REQUEST FOR INFORMATION

TO: Artie St. Onge	FROM: Mike Davis / Mike Weigand
COMPANY: A.L. St. Onge Contractor	DATE: 5/19/16
FAX NUMBER: 802-326-4005	TOTAL NO. OF PAGES INCLUDING COVER: 2 plus Attachment
PHONE NUMBER: 802-326-4792	SENDER'S REFERENCE NUMBER: RFI #7-1
RE: Waitsfield BRF 013-4(39) - Bridge No. 177; VT 100 over Mad River Waitsfield, VT

RFI #7-1: Proposal to Field Drill Swedged Anchors

5-18-16
 J. P. Carrara & Sons, Inc.
 RFI #7; JPC SK-1

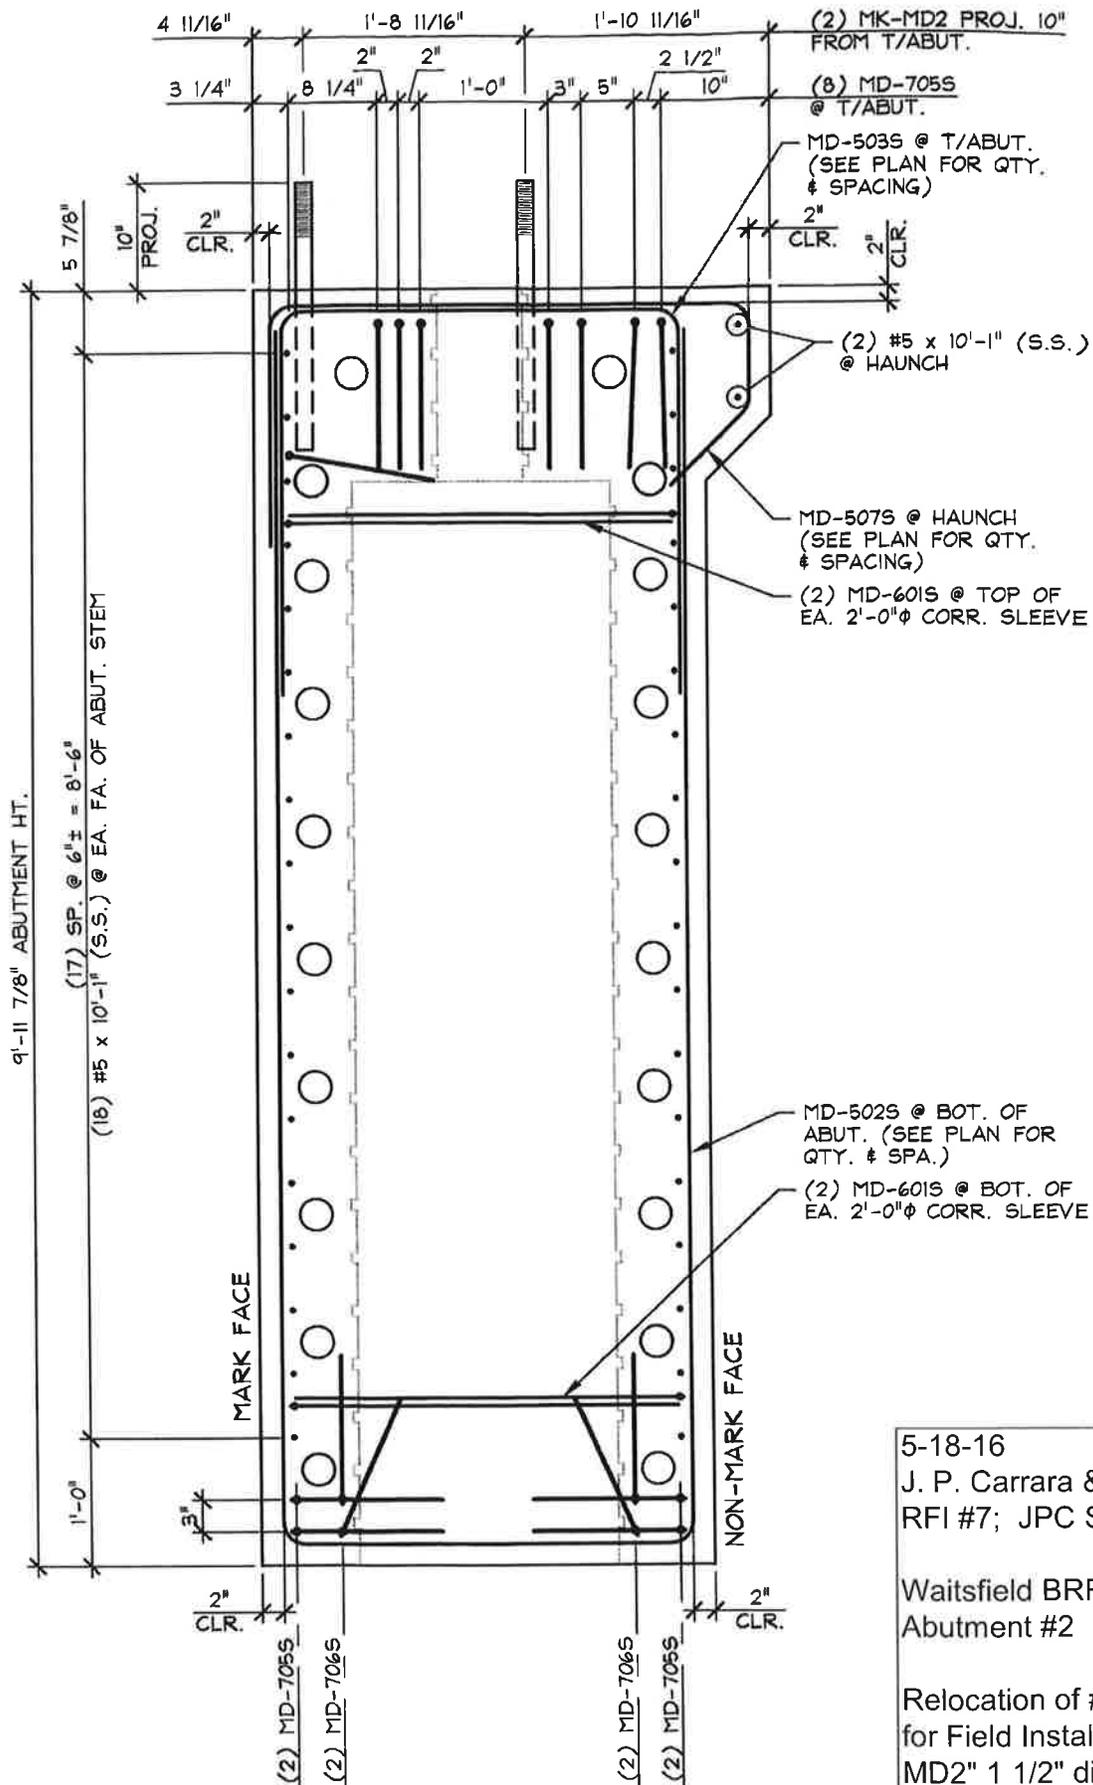
Abutment #2:

Core drill 1 3/4" diameter x 1'3" long hole and install 1 1/2" diameter Swedged Anchors using Epcon Acrylic 7 adhesive anchoring system in accordance with manufacturer's instructions.

JPC shall mark the top surface of the precast pile caps at the locations where anchors shall be field drilled using the dimensions indicated in the approved as noted shop drawings. For pile caps, it is critical that field drilling avoid the location of post-tensioning and the (8) #7 continuous longitudinal bars in the top row of the units. To this end the #7 bars shall be located as shown on the attached JPC reinforcing schematic sketch, JPC sketch SK-1. JPC shall make small shifts in other reinforcement as may be possible to avoid the locations where field drilling shall be performed, however field drilling may cut the other reinforcement.

Relocation of #7 Bent Bars
 for Field Installation of "MK-
 MD2" 1 1/2" diameter
 Swedged Anchor Bolts, 1'3"
 max. embedment
